TANDBERG TAPE RECORDER INFORMATION

No. 104
Oslo, 2nd December 1970

Series 3000X/6000X

Modified take-up clutch

Bottom view of take-up turntable and friction disc.

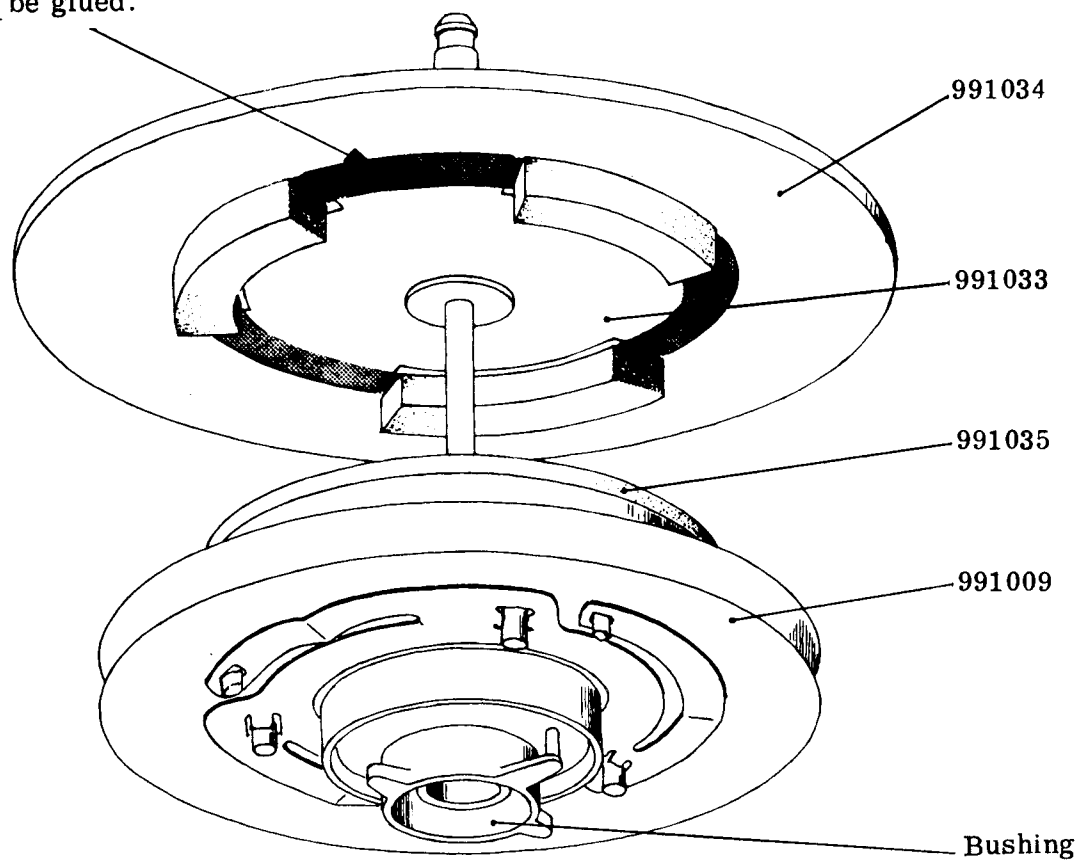
The materials originally used in the take-up clutch have after prolonged operation in hot environments in some cases shown a tendency of excessive wear.

Clutch components in a better material were introduced in production from the following serial numbers:

In some units, the bushing in the friction disc has a wide flap instead of a small stud to prevent rotation. The bushing with the flap can be snapped out of the bearing by means of a screwdriver and must be installed in the new friction disc to facilitate the rest of the assembly

The hatched areas indicate the adhesive coating holding the friction pads. The mylar sheet must not be glued.

1 ea take-up turntable with friction pads, and mylar sheet with felt part No. 991034

1 ea take-up friction disc with coupling disc, spring, ball bearing and bushing part No. 991009
